Declaration Letter

Fengmi (Beijing) Technology Co., Ltd.

Updated power board:

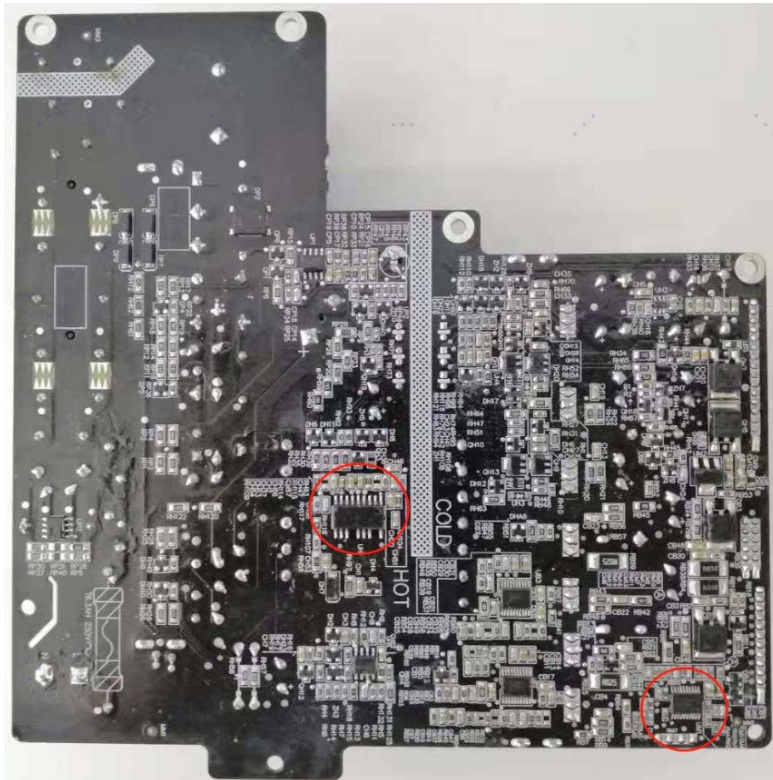
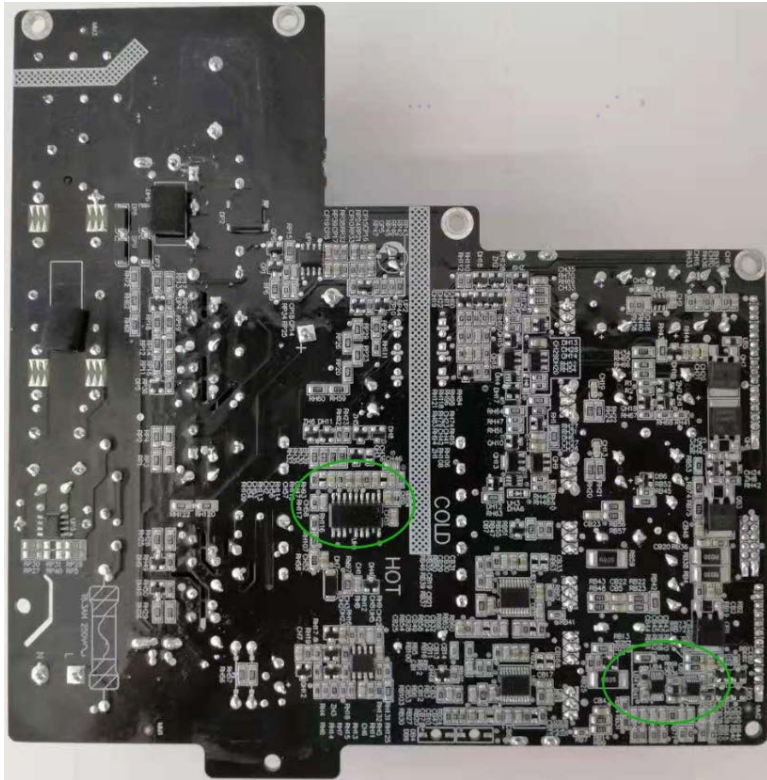
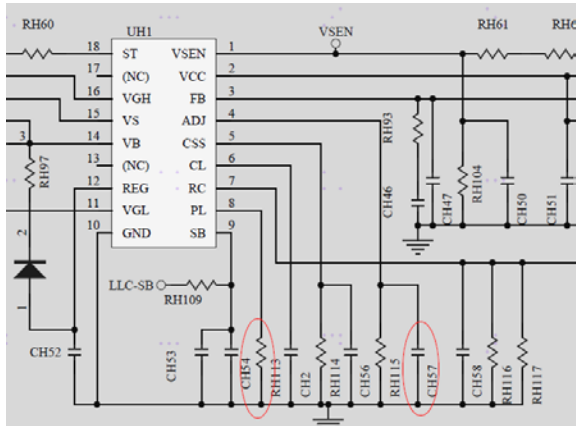
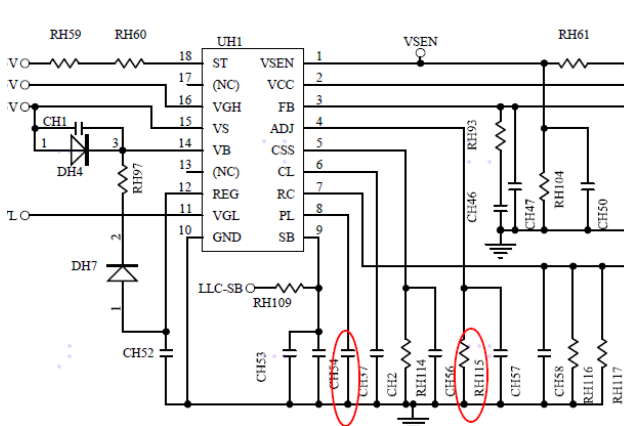
Difference items	Previous power board	Updated power board
Control chip (UH1)	Pin 4 connected with CH57 0.01uf capacitor Pin 8 connected with 100kΩ RH113 resistance.	Pin 4 connected with RH115 100kΩ resistance. Pin 8 connected with CH37 0.1uF capacitor.
Components	2pcs digital potentiometer UB1 & UB4	MCU chip UM1
Diagram
